**TOWN OF YORKTOWN
PLANNING BOARD**

**PUBLIC MEETING AGENDA
YORKTOWN TOWN HALL BOARD ROOM
363 Underhill Avenue, Yorktown Heights, NY 10598**

**September 12, 2022
7:00 PM**

4 (TYP.) ROOF TRANSITION DETAIL
SCALE: 1-1/2" = 1'-0"

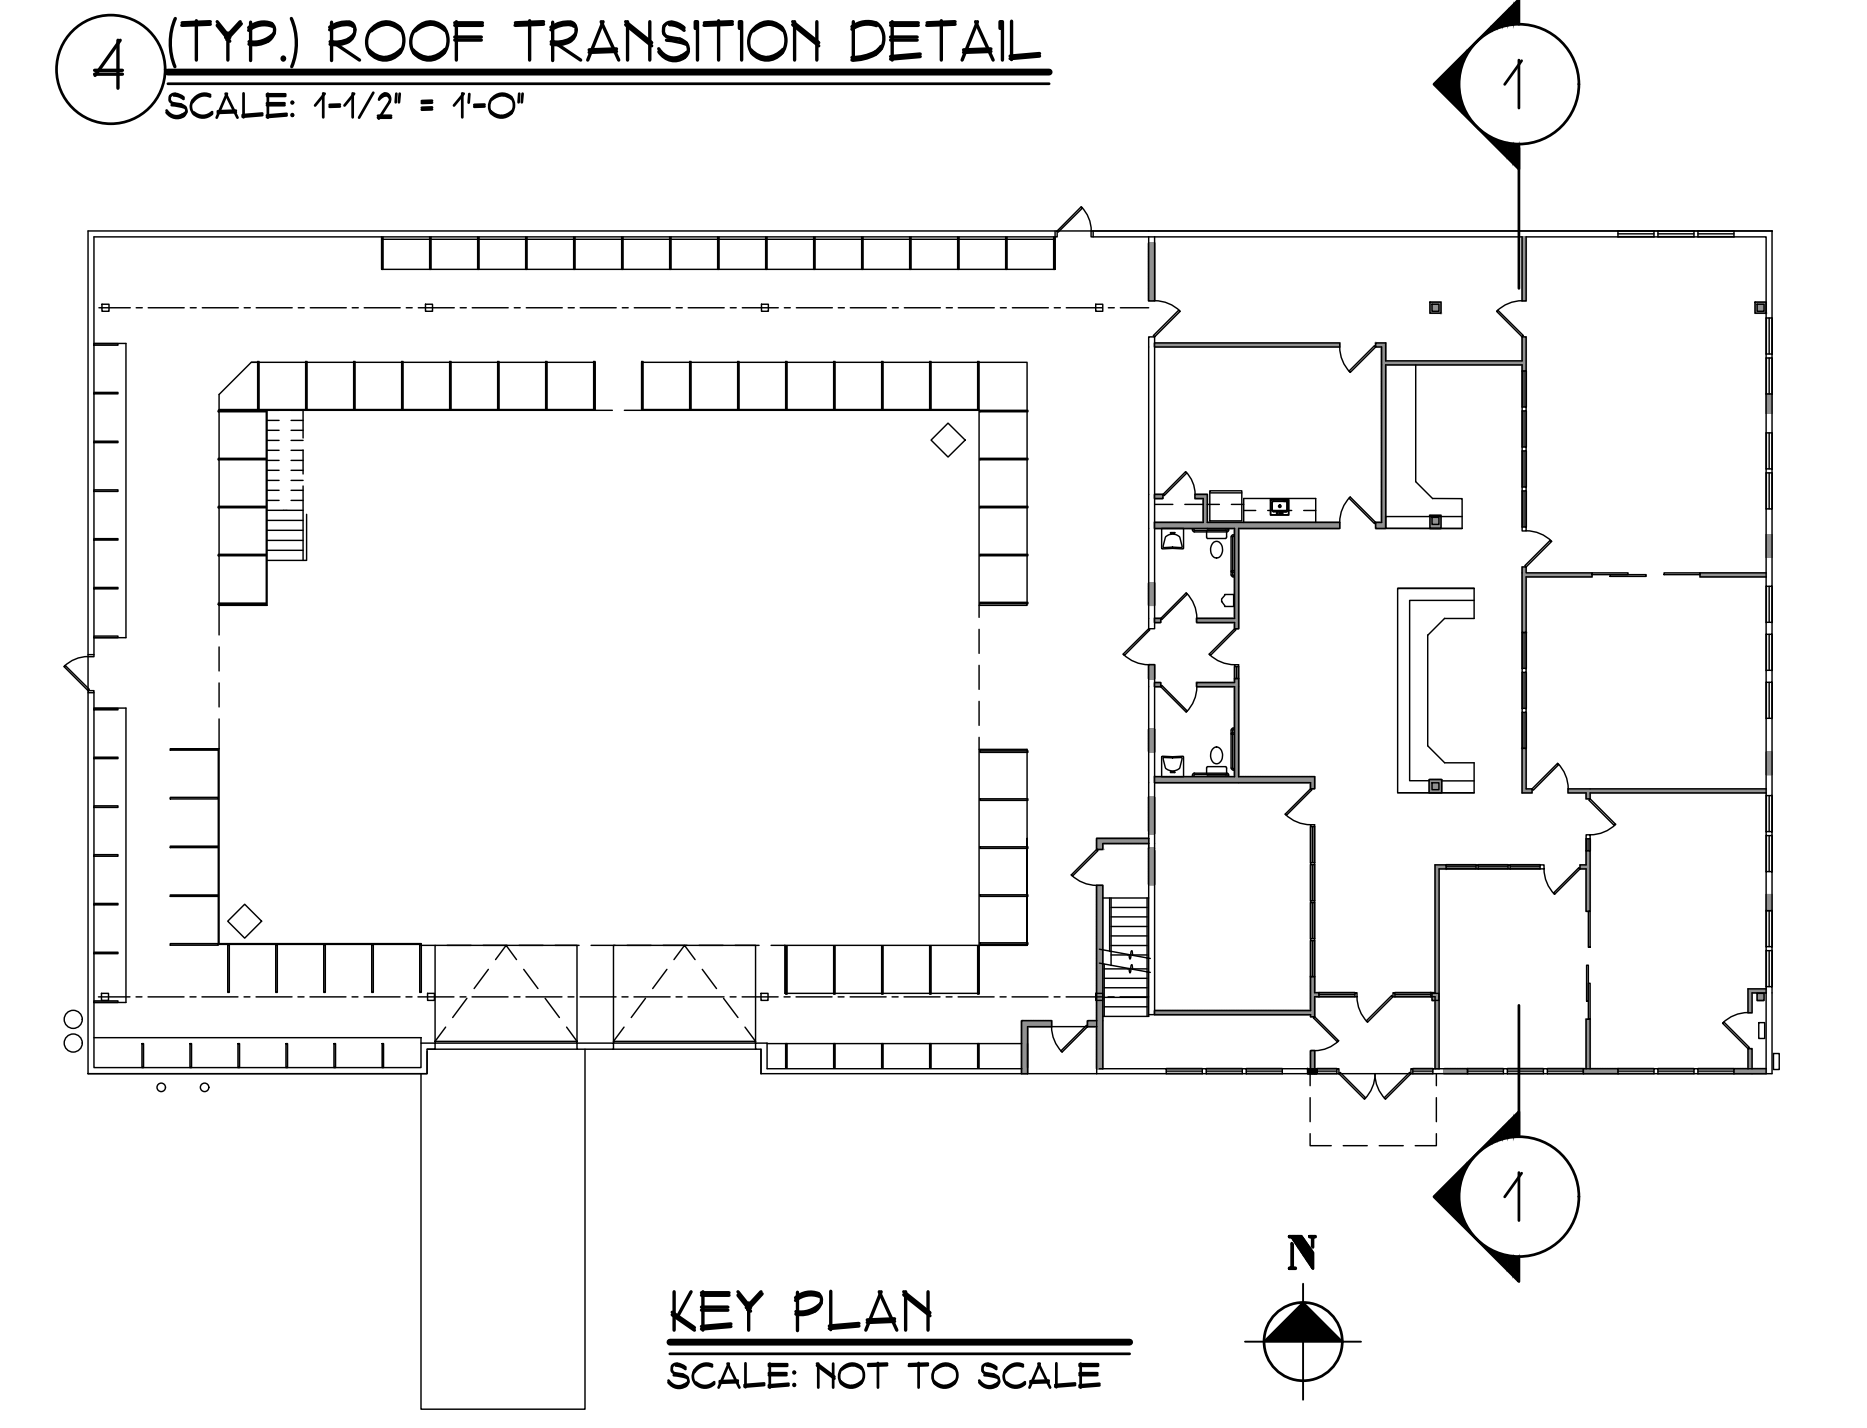
1. **Metal Roofing Detail** – One of the Members of the Board requested that we provide a Detail indicating the transition between the new Architectural style asphalt roof shingles and the standing seam metal roof. We have reviewed this condition with the Manufacturer of the metal roofing and have included a Detail on Drawing A-3, (Detail 4 entitled: Typical Roof Transition Detail).

FLASHING AT ASPHALT TO METAL ROOF TRANSITION. PROVIDE ZEE CLOSURE W/ BUTYL SEALANT AT STANDING SEAMS & WOOD BLOCKING AS REQUIRED. OVERLAP ASPHALT SHINGLES OVER FLASHING. (SEE ENLARGED TRANSITION DETAIL #4 ON THIS SHEET)
